Packet Guide
City of Charlottesville
Board of Architectural Review
Regular Meeting
January 22, 2025 5:30 p.m.
Hybrid Meeting (In-person at Council Chamber and virtual via Zoom)

BAR #HST24-0036

606 Lyons Court; TMP 520063000 North Downtown ADC District

Project: Alterations to house and site

### 1913 Sanborn Map: 144 Chancellor Street

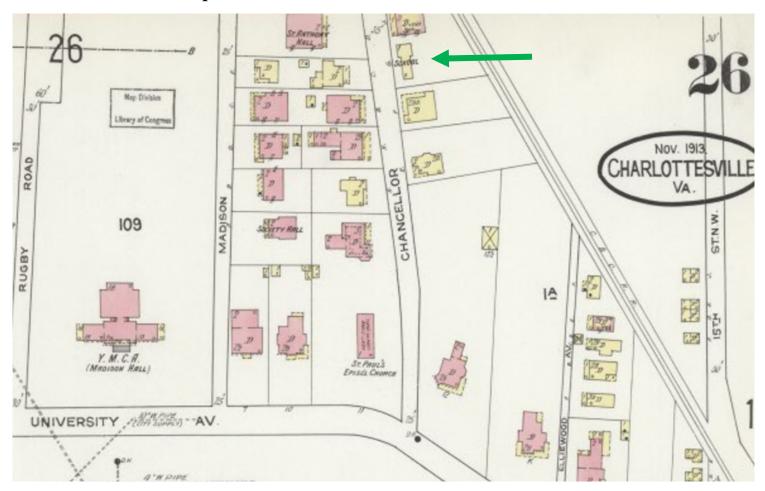
**144 Chancellor Street** School, single-story, wood-framed, shingle roof

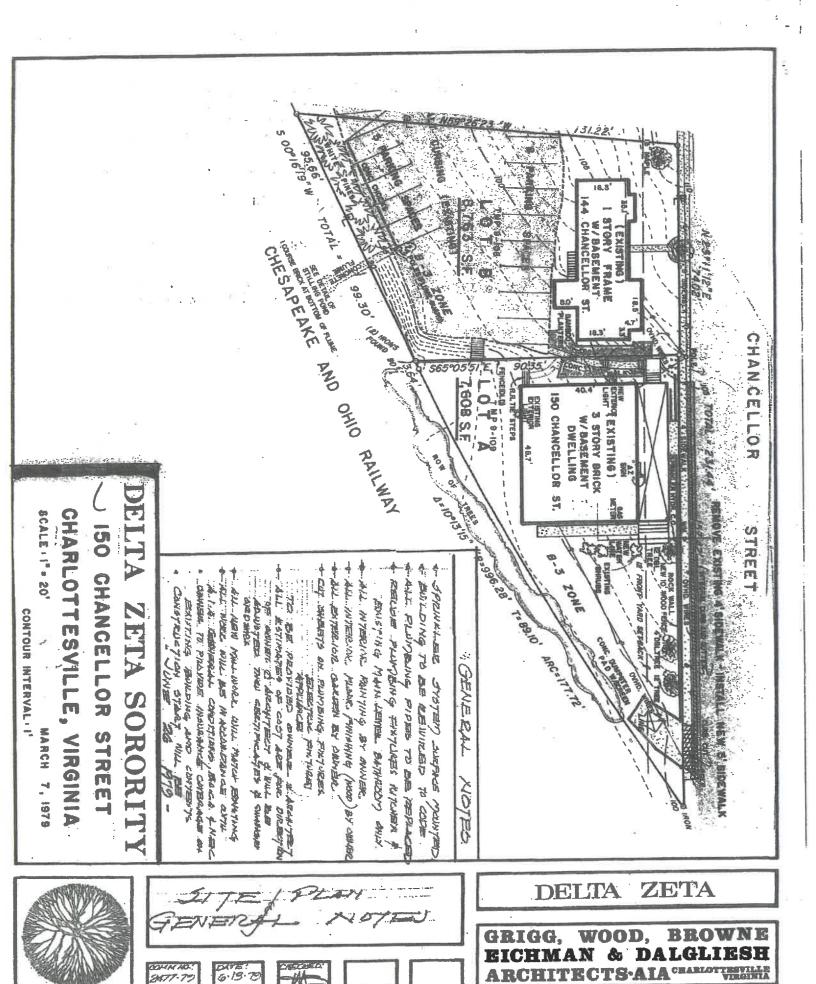
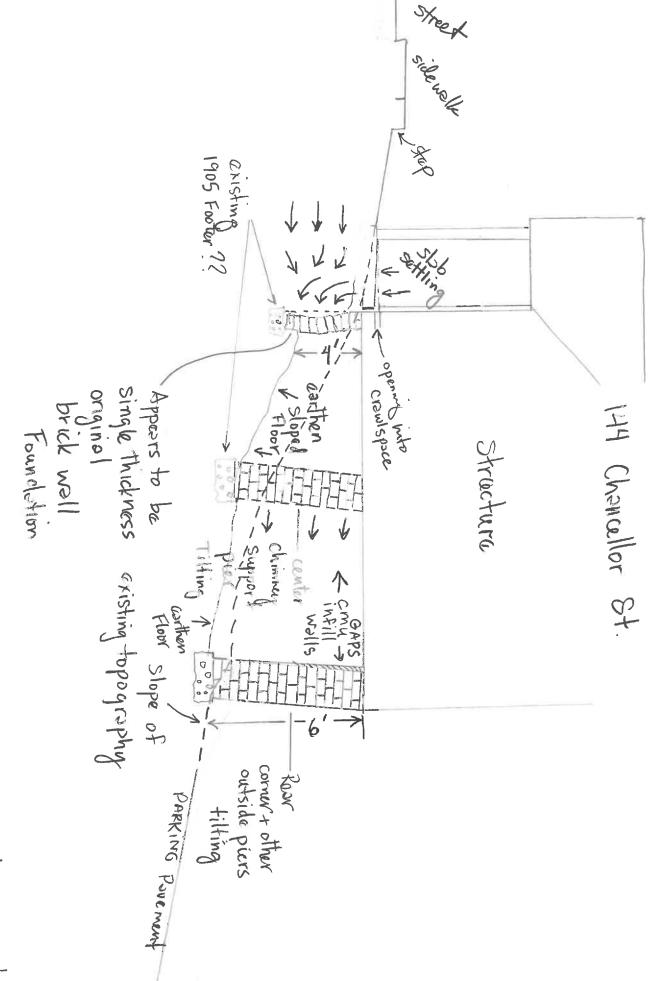
- The west side brick retaining wall appears to be failing.
- The CMU walls do not appear to be connected at the top and are unstable in the out of plane direction of the wall.
- The slope of the ground is permitting water to build up and infiltrate the west side of the building.

- Excavate and remove the existing backfill along the west side of the building.
- Repair or replace the existing brick retaining wall. This would consist of 35ft of wall.
- Install a foundation subdrain that outlets to daylight or suitable drain. Install a
  waterproofing system against the below grade walls. Replace backfill along
  the west wall with an open graded stone such as VDOT No. 57.
- Connect the perimeter CMU infill to the brick masonry piers. This could be accomplished with a 2x ledger board and adhesive anchors.
- Connect the building perimeter sill plate to the CMU infill walls.
- Generally performed repairs to the damaged and cracked masonry. This work would involve extensive repointing.

The above repair work would be extensive with the repair costs making up a significant fraction of a complete replacement of the building.

In consideration of the floor joists, we consider the joists to be capable of supporting light storage provided the supporting masonry walls and piers are repaired.
